ADDENDUM

ADDENDUM NO. 3

RE: New Bedford Marine Commerce Terminal
Phase 3 Bulkhead Replacement (Site 4)
Massachusetts Clean Energy Technology Center
Contract No. MACEC-FY26-02

GENERAL NOTES:
1. PILE TO PLATFORM CONNECTIONS NOT SHOWN FOR CLARITY.

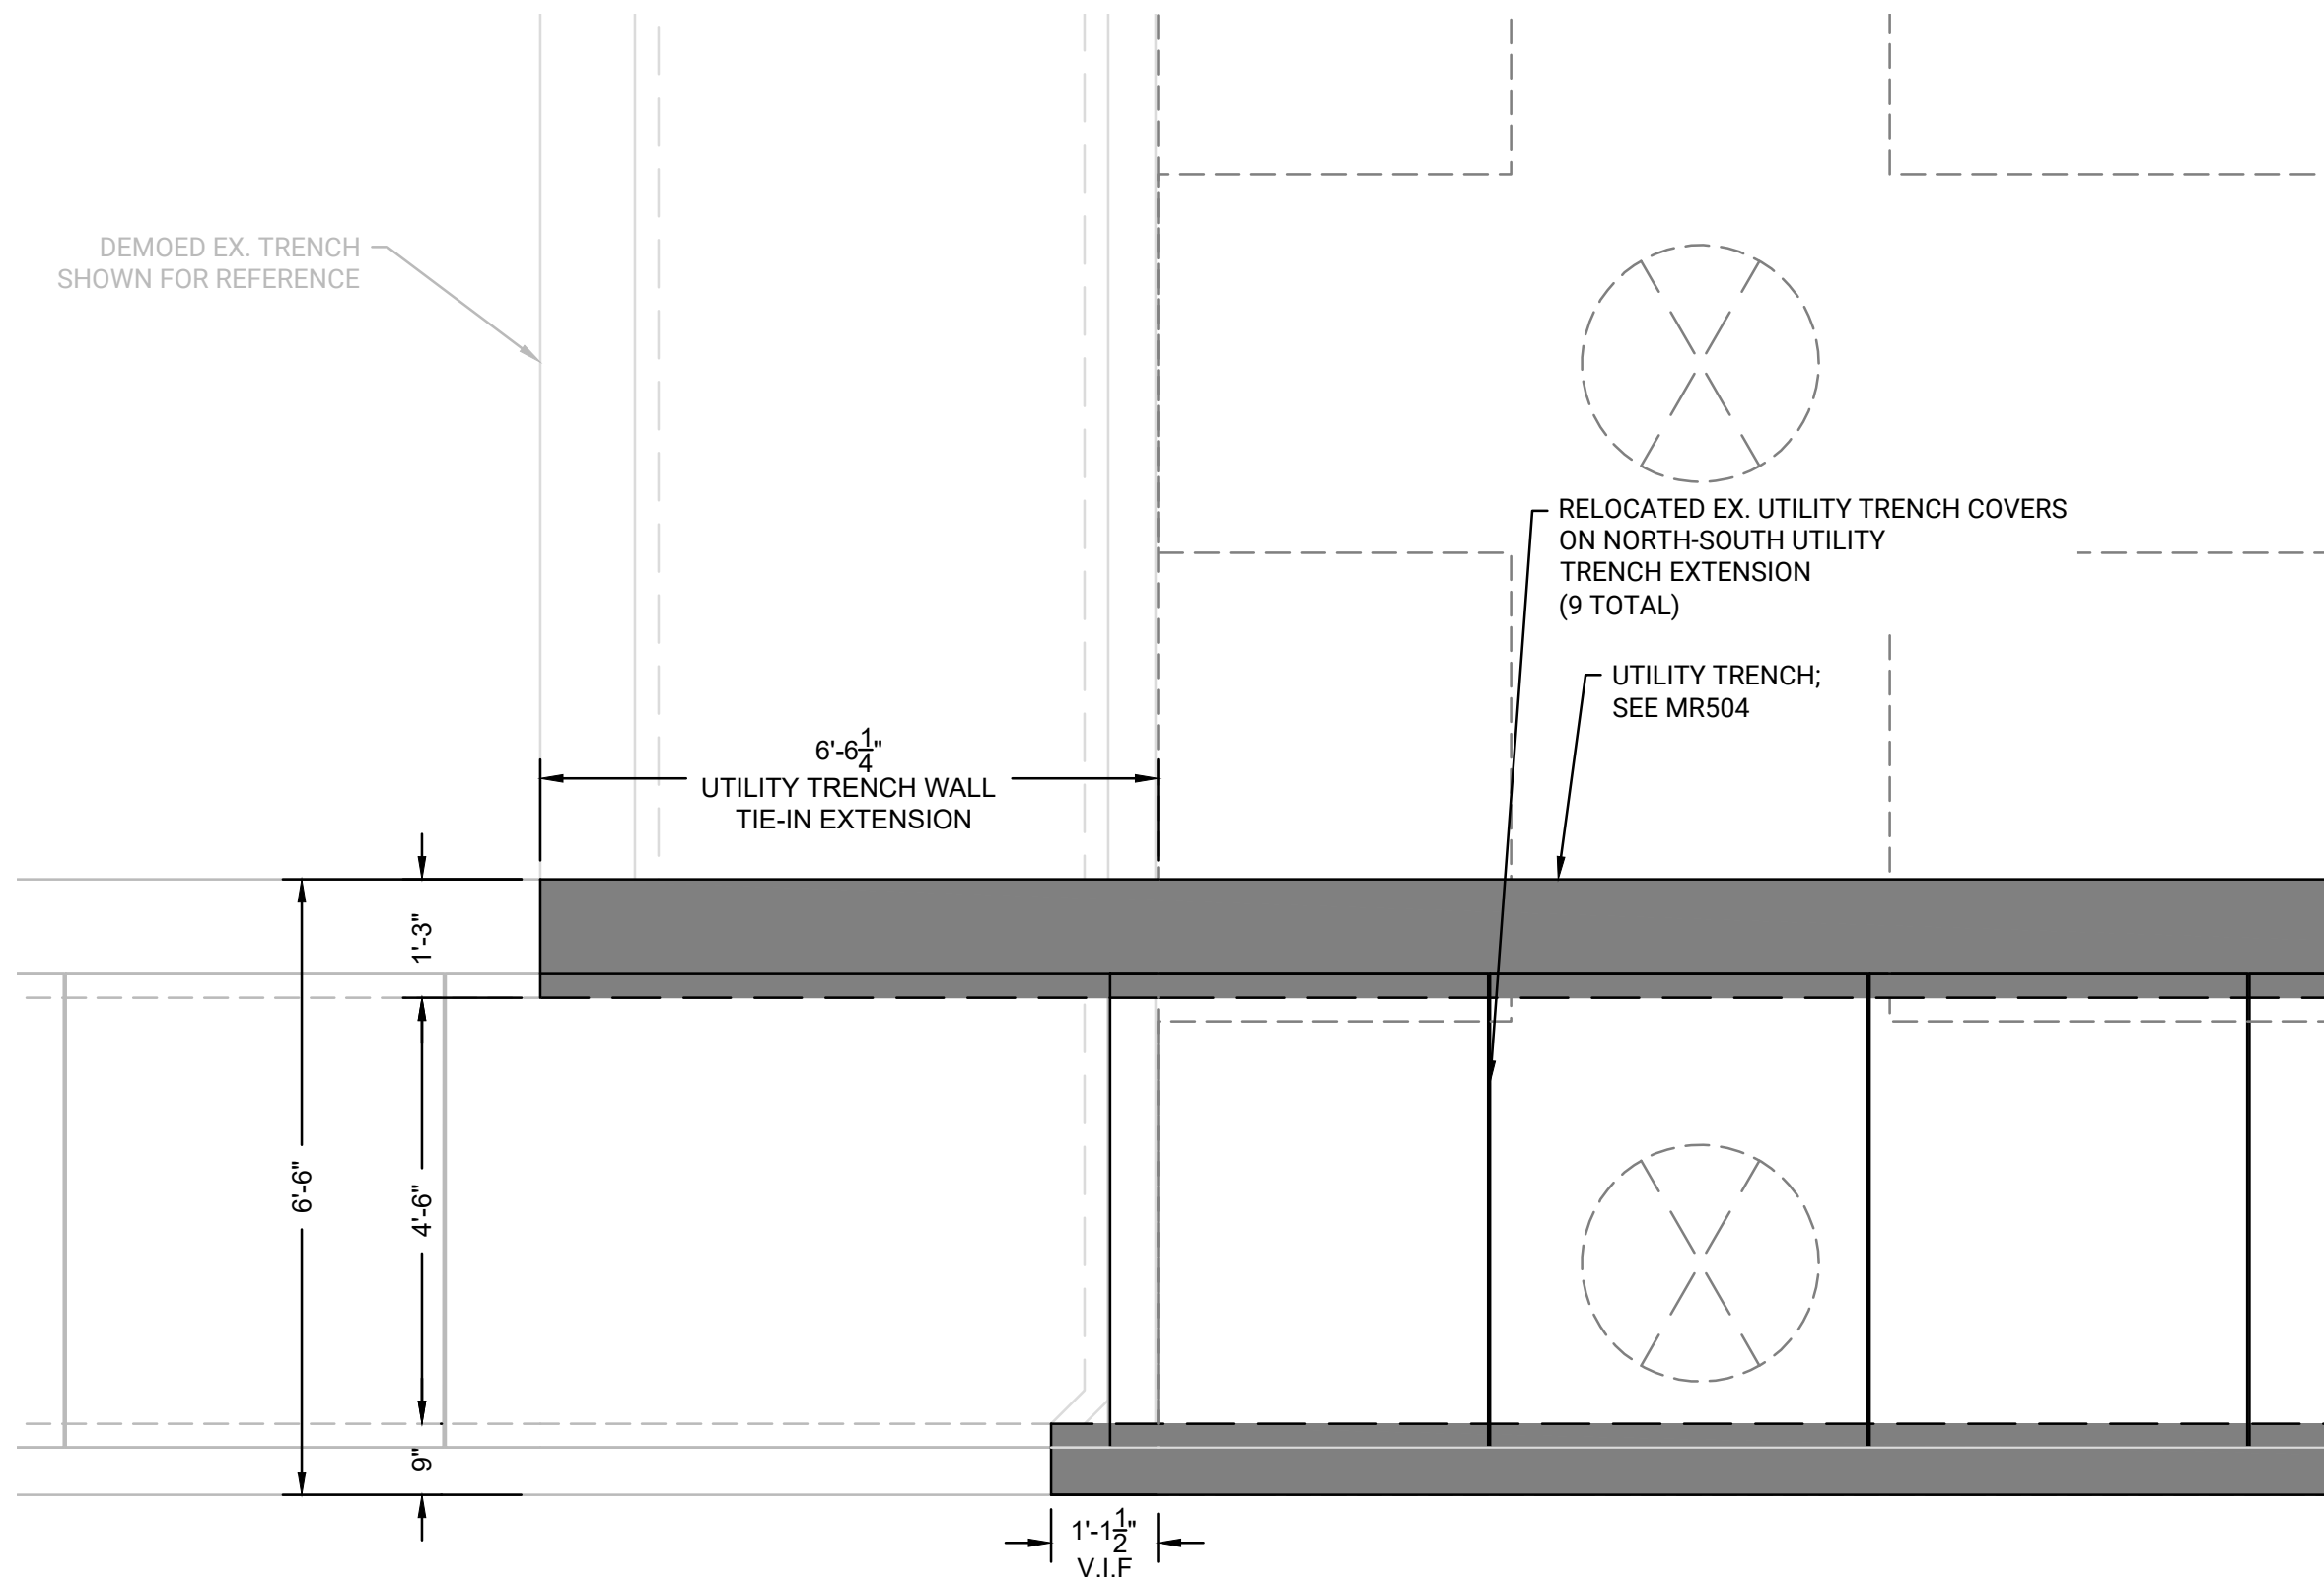
3. Drawings MR100 and MR515 have been revised to reflect structural revisions addressing Question #3 (below). The revised Drawings are provided in **Attachment 1** to this Addendum No. 3.

1. Q: Will spiral weld pipe be acceptable?
A: YES, spiral weld pipe will be allowable steel pipe pile product.
2. Q: Are Pile Caps PC-1 to PC-8 connected to each other? If so, please provide a connections detail.
A: Please refer to the revised Drawings MR102 and MR508 through MR511, and the new Drawing MR511A. PC-1 through PC-6 have been resized and detailed to address precast pile cap connections.
3. Q: Please refer to the snapshot below from MR017. The red hatched area represents a gap between the proposed platform slab and existing Cofferdam cell which will be exposed to the open water below. Please provide a closure detail between the proposed platform slab and Cofferdam Cell to close this space.

- A: The red hatched area will be covered through an extension of the portion of the new platform beams and slabs with concrete headwall. The location and size of the extension is shown on the revised Drawings MR100 and MR515 in **Attachment 1**. All associated work shall be included in Bid Item #38.

PRECAST
PILE CAP
DETAIL 5 OF 7

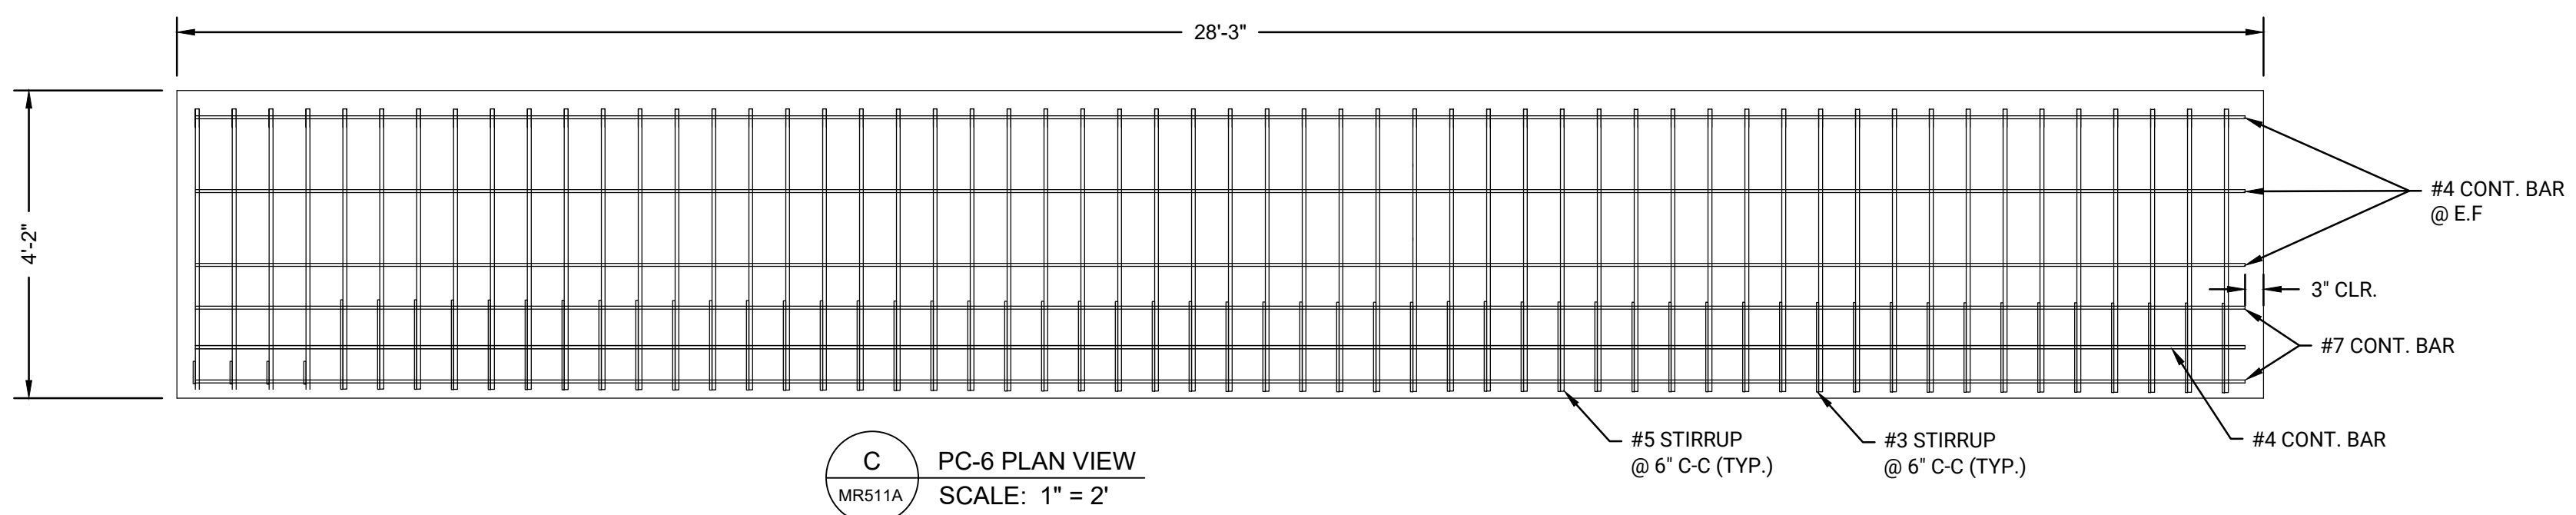
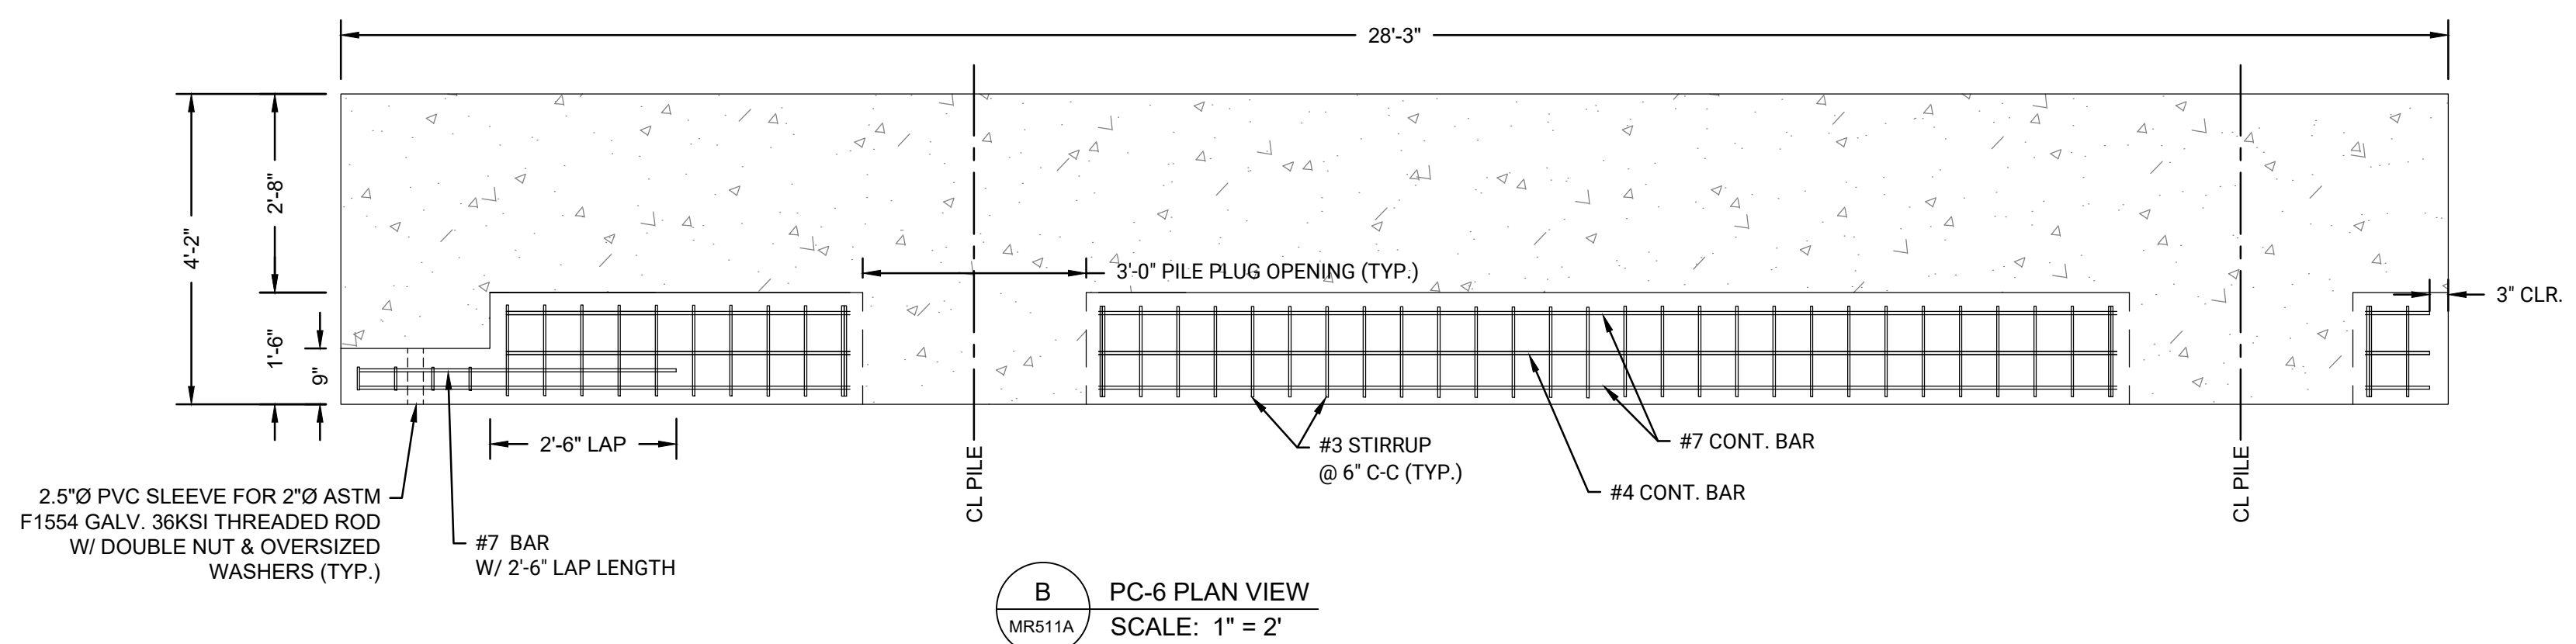
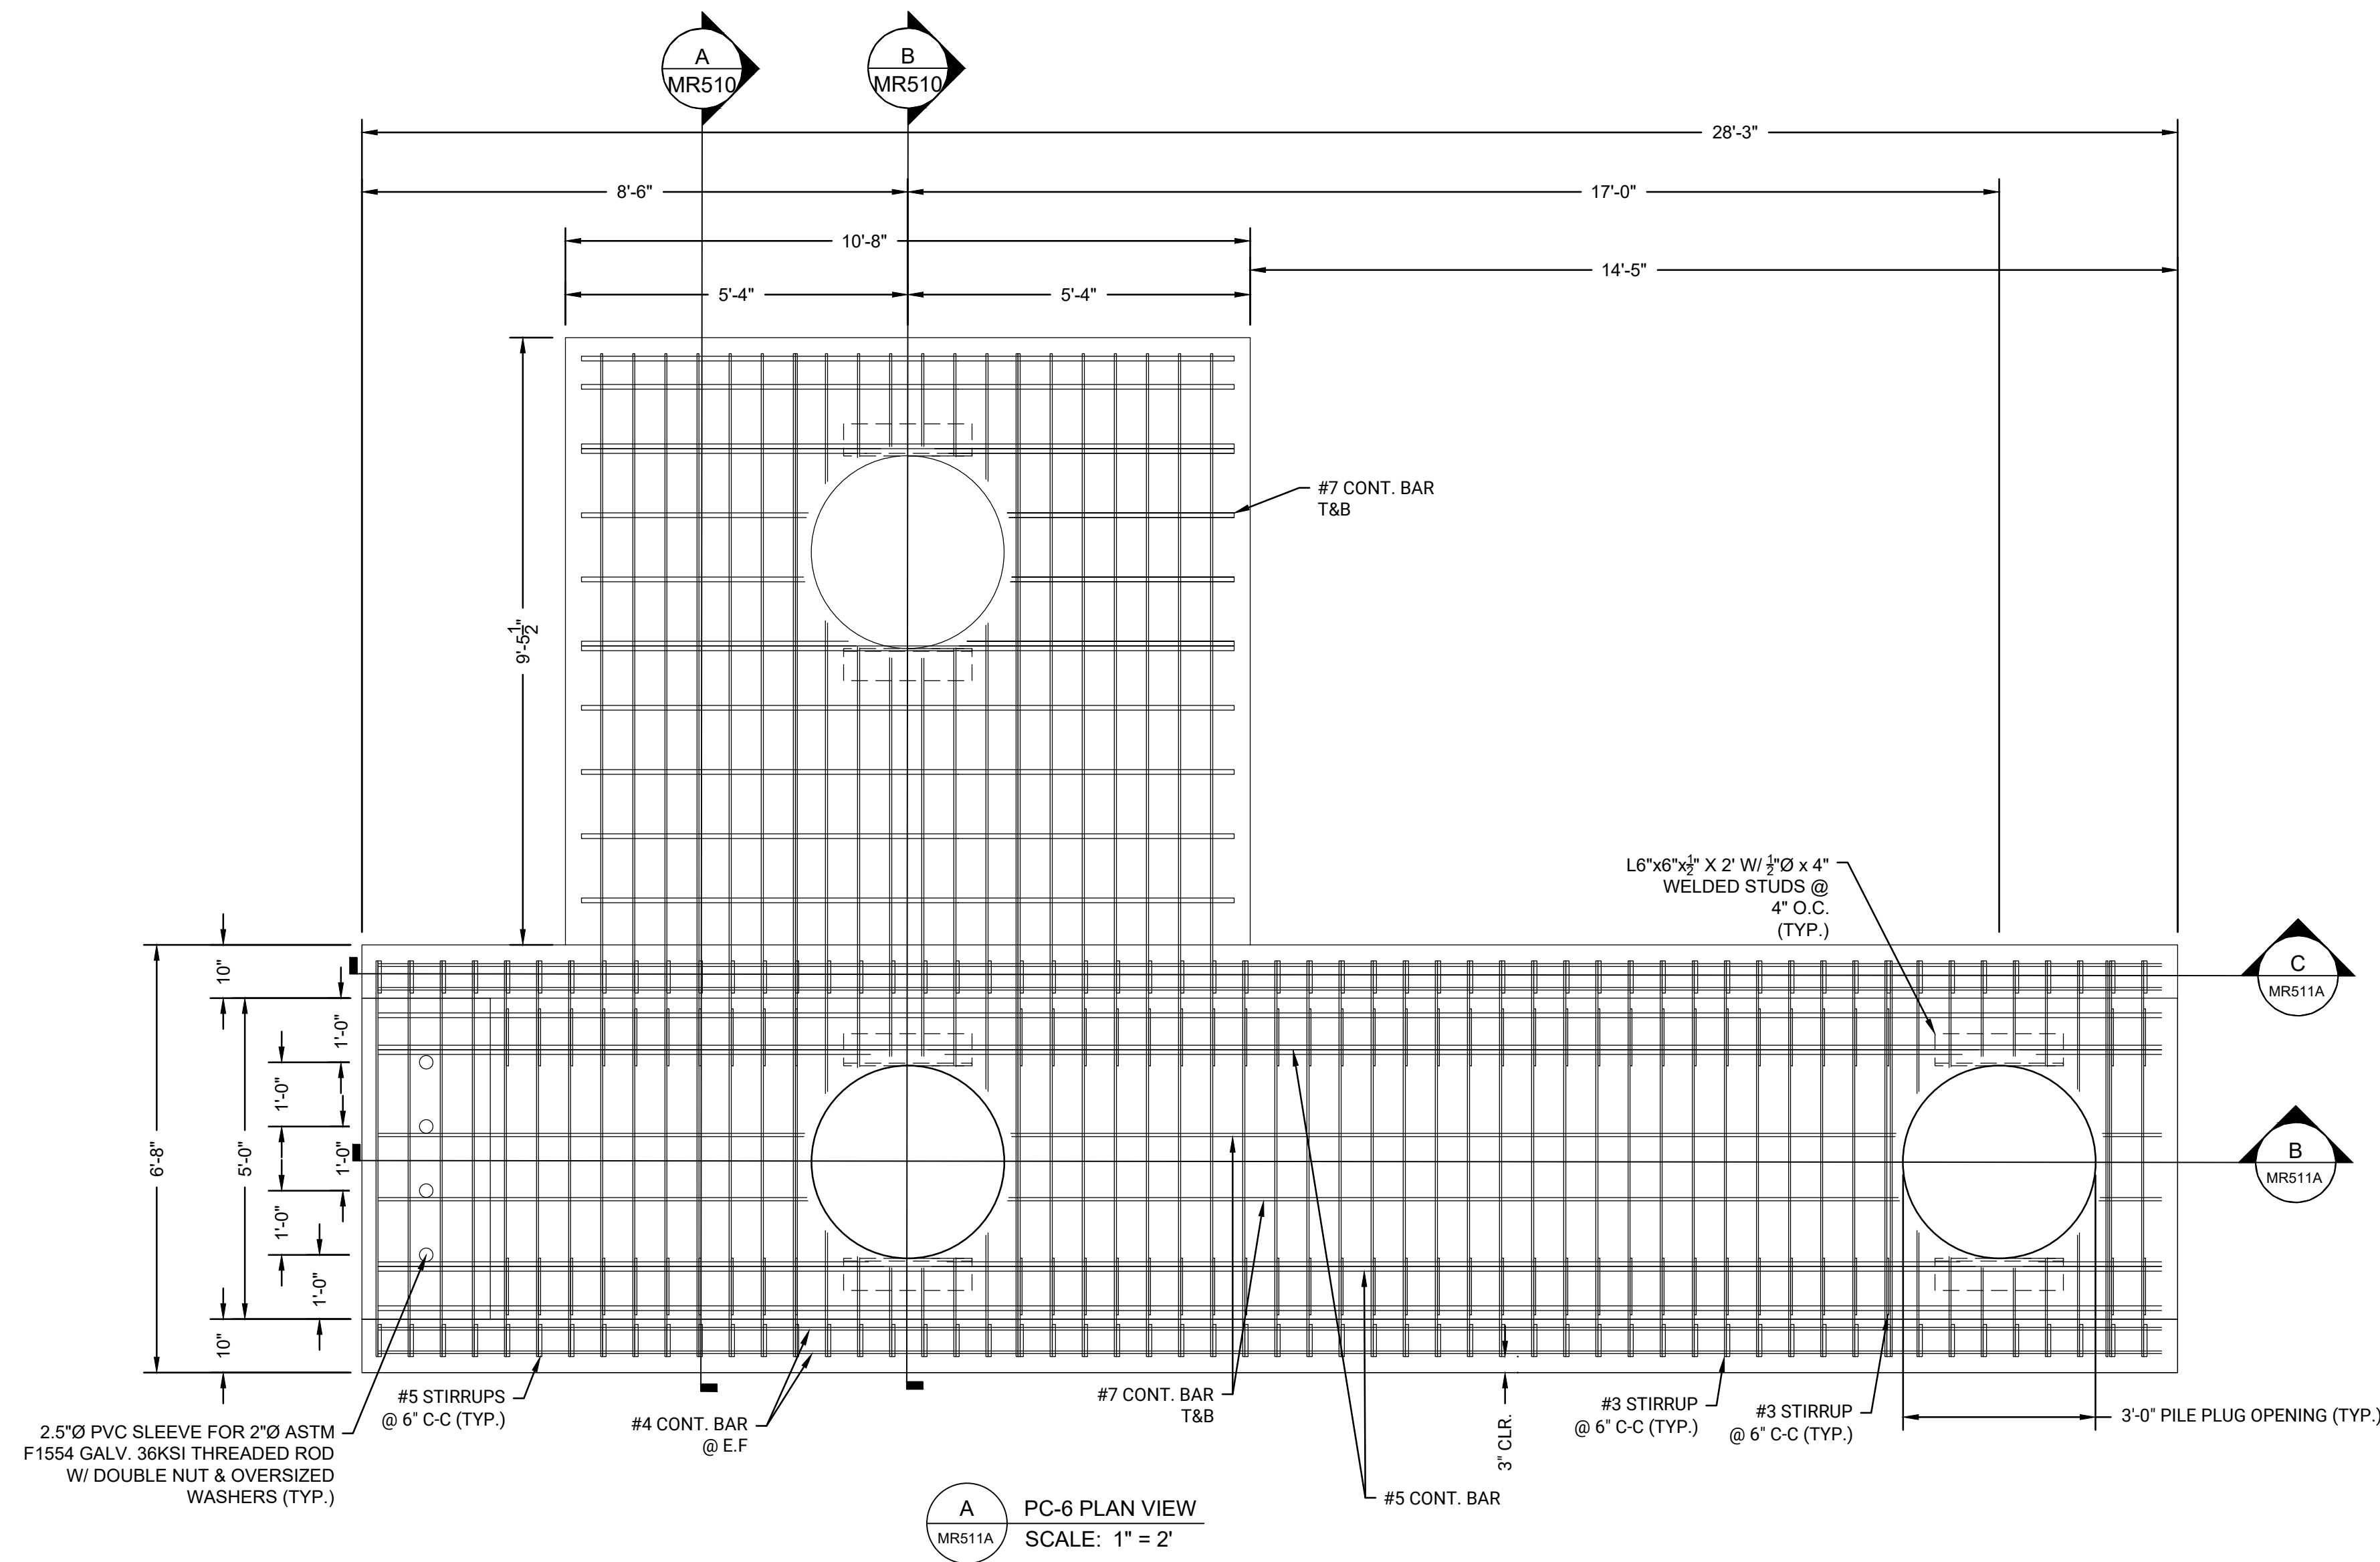
2. Drawing MR511A has been added to the Issued for Bid Drawing set to reflect precast pile cap configuration addressing Question #2 (below). The new Drawing is provided in **Attachment 2** to this Addendum No. 3.
